Architect's Supplemental Instructions

Architect's Project No: 04561.01
Architect's ASI No: 040

Project:
Webster University
Interdisciplinary Science
Building

Date Issued: 12/09/2016

T0103.A

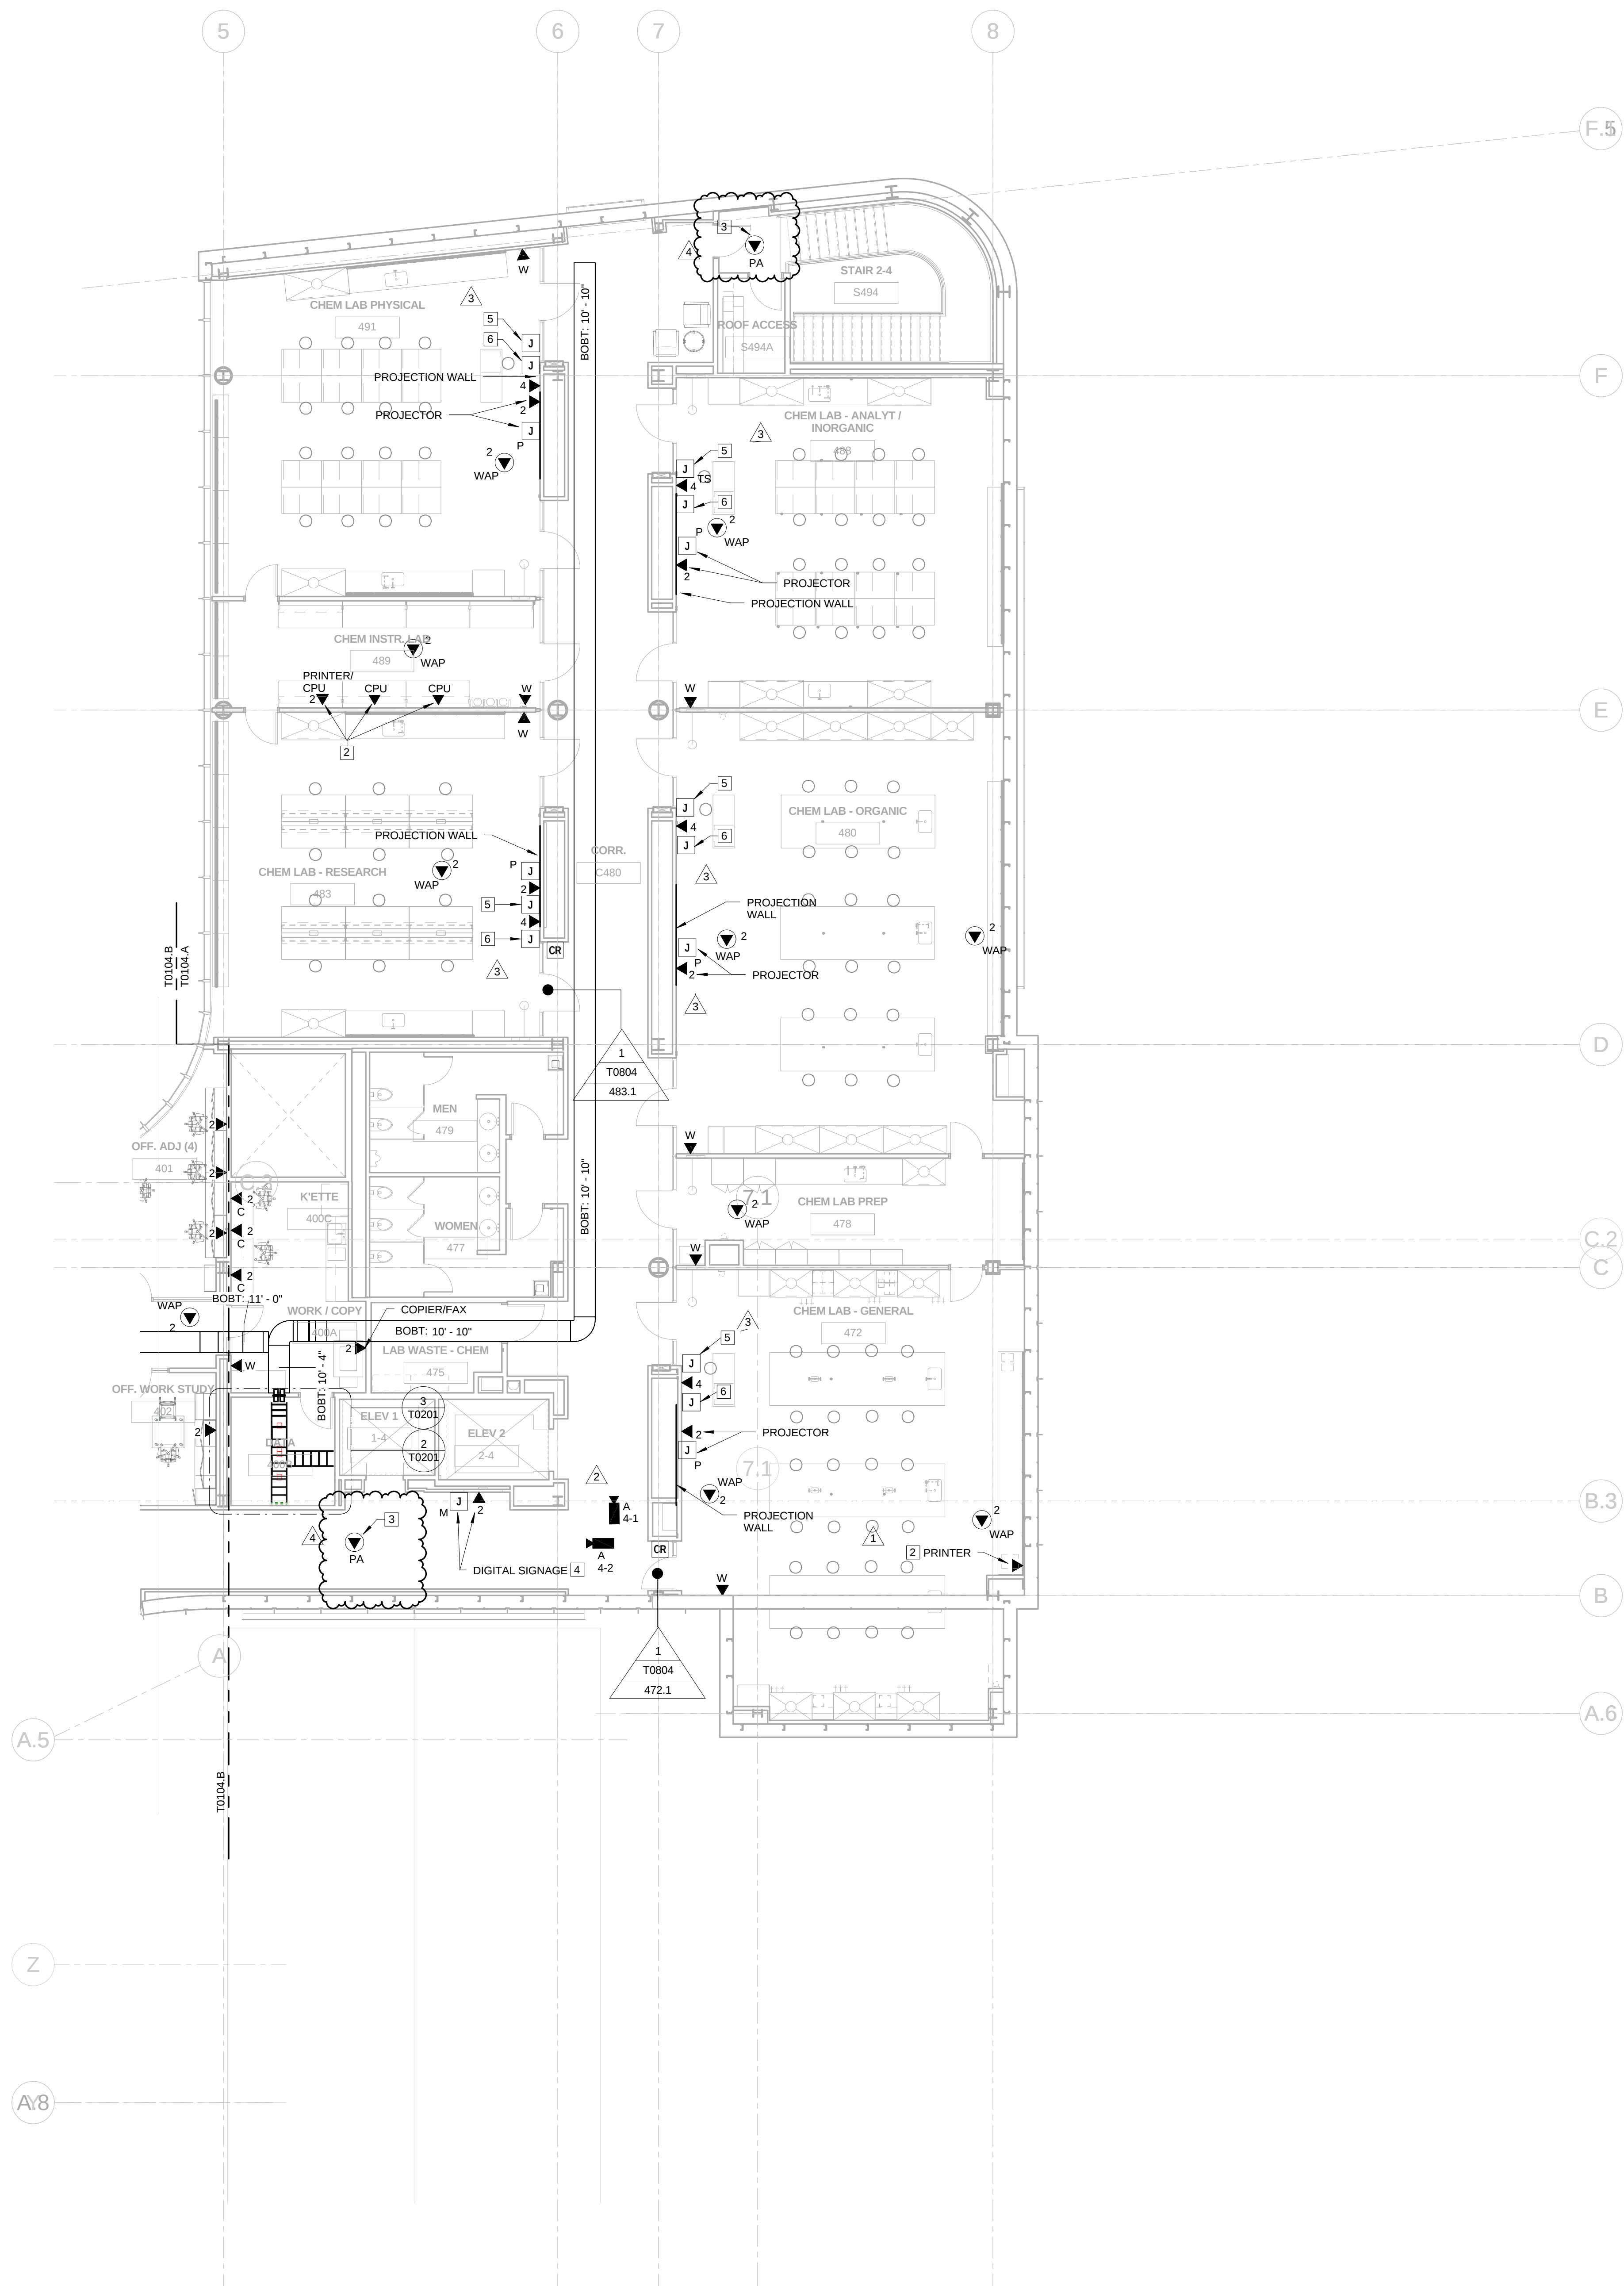
- A. Moved PA location from wall to ceiling.
 - B. Revised keyed note 6 to reflect this change.
8. T0103.A – LEVEL 03 FLOOR PLAN – AREA B

- A. Moved PA location from wall to ceiling.
 - B. Revised keyed note 4 to reflect this change.
9. T0104.A – LEVEL 04 FLOOR PLAN – AREA B
- A. Moved PA location from wall to ceiling.
 - B. Revised keyed note 3 to reflect this change.

1. CABINET MOUNTED AV EQUIPMENT (OFVI)
2. CONFIRM EXACT LOCATION OF DATA OUTLET AND MONITOR WITH AV VENDOR PRIOR TO INSTALLATION.
3. INSTALL COMMUNICATION OUTLET IN THE COMMUNICATIONS SIDE OF THE 2 CHANNEL RACEWAY. SEE ELECTRICAL DRAWINGS FOR RACEWAY INFORMATION.
4. COORDINATE EXACT LOCATION WITH PA INSTALLER.
5. PROVIDE (1) 4-11/16" SQUARE X 2-1/8" DEEP BOX WITH 2 GANG RING AND (1) 1" CONDUIT STUBBED INTO ACCESSIBLE CEILING SPACE FOR AV KEYPAD. PROVIDE (1) CAT 6A CABLE TO DATA ROOM IDENTIFIED ON PLANS. MOUNT AT LIGHT SWITCH HEIGHT.
6. PROVIDE (1) 4-11/16" SQUARE X 2-1/8" DEEP BOX WITH 2 GANG RING FOR THE AV INPUT PLATE. MOUNT AT RECEPTACLE HEIGHT. PROVIDE (1) 1" CONDUIT UP TO THE AV KEYPAD J-BOX. (SEE KEYED NOTE 5).
